Replacing the E102 CRT Monitor by the Monitor Unit FSU201

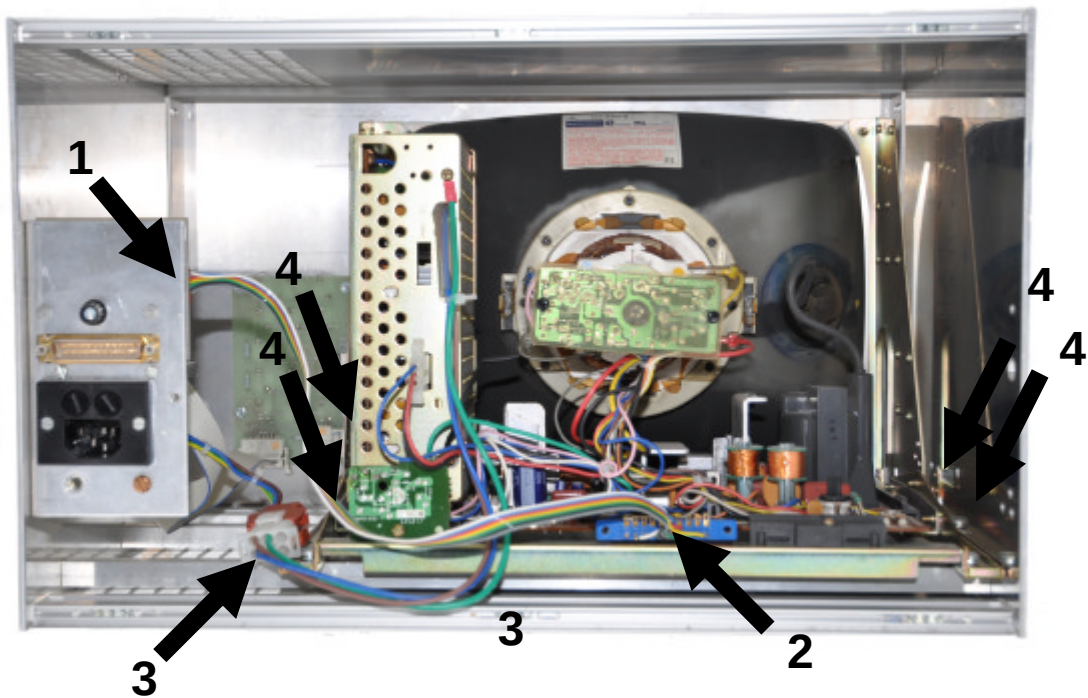
1. Remove the upper and the back cover of the operating station.
2. Disconnect the signal cable from the connector plate (1), and the monitor (2). The cable is no more used. Disconnect the monitor power cable (3). Remove the four screws, that are used to mount the monitor on the chassis (4). Remove the monitor from the chassis.

2. Remove the four mounting brackets (5) that are attached at the screen window. Therefore, unscrew the ten nuts (6) at the back side of the panel front. The mounting brackets are no more used.

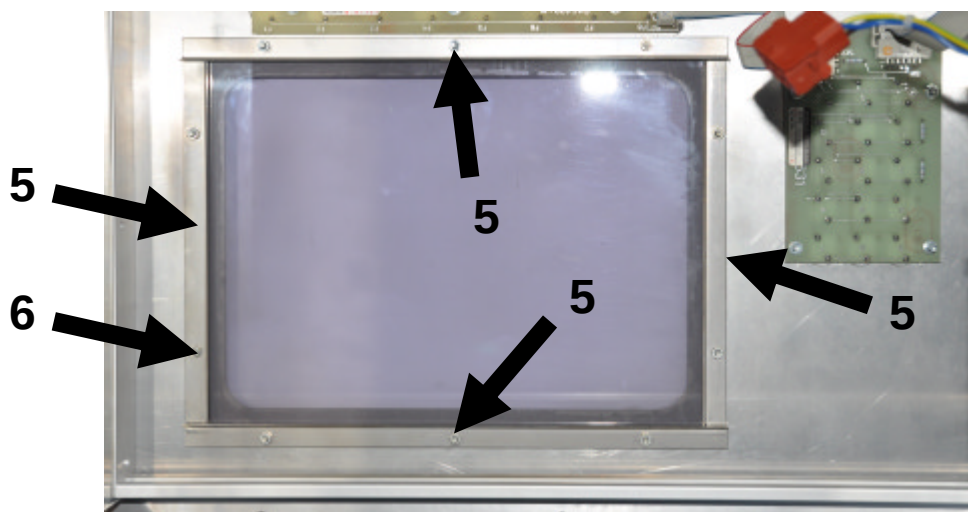
3. Install the Monitor Unit FSU201 and mount it with the four supplied screws at the chassis (7).
4. Plug in Connection Cable 731.426.33 at the FSU201 (8) and the connector plate (9).
5. Connect the FSU201 power cable to the free chassis power connector (10).
6. Remount the upper and the back cover of the operating station.
